Re. Reports G21073 (Phase 1) and G21103 (Phase 2) – Proposed Development Land at Dearne Grange Farm, Cumberworth HD8 8YA

Further to my earlier response of 7th June 2021, I offer the following additional information regarding the ground gas risk assessment for the above site.

Looking east towards suspect area (circled):

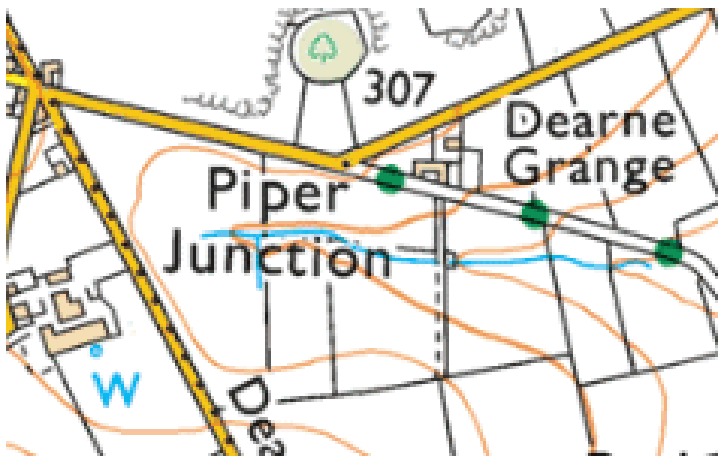
- The distance from the site illustrated by the 3rd image on the previous page highlights how unlikely the potential for lateral gas migration to the site is.

- The clear drop in elevation to the stream from both the north and south sides suggest that there is no possible pathway for gas migration. Even if the steep south bank of the stream (visible in the first photo) comprises artificially raised ground, this would require the ground gas to migrate down-over and then laterally >200m to the study site. Clearly this is impossible, and it is much more likely that it would rise to surface close to source, or potentially remain at the source.

- It is highly unlikely, however, that this comprises raised ground because the feature does not match the area highlighted on the local authority plan presented earlier, and also appears to have been present on the earliest OS maps.

BGS map extract:

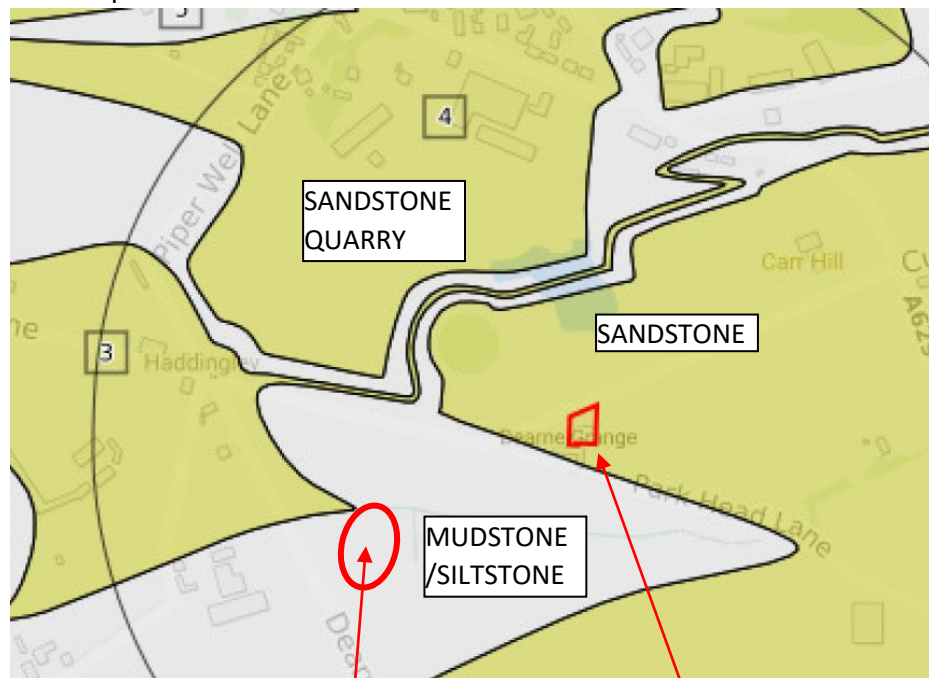
- The BGS maps the area in question, and the area between that location and the study site, to be underlain by mudstone or siltstone with no overlying superficial deposits. As such, no pathway would be expected to be possible through this impermeable or low permeability rock. The BGS map is reproduced on the following page for reference (as presented in the desk study report).

- The presence of the (green) sandstone to the north of the study site approximately matches the footprint of the large quarry, suggesting that the mapping is accurate. Mudstone would most likely have marked the extent of the quarrying activity if sandstone was the extracted material.

- This also further supports the theory that the area in question to the southwest has not been quarried and infilled.
- The rock in the grey mapped areas is more likely to be mudstone than siltstone given the findings of a borehole record to the south in the same stratum, further suggesting extremely low permeability and negligible potential for gas migration. This borehole found mudstone and sandstone with no siltstone strata.
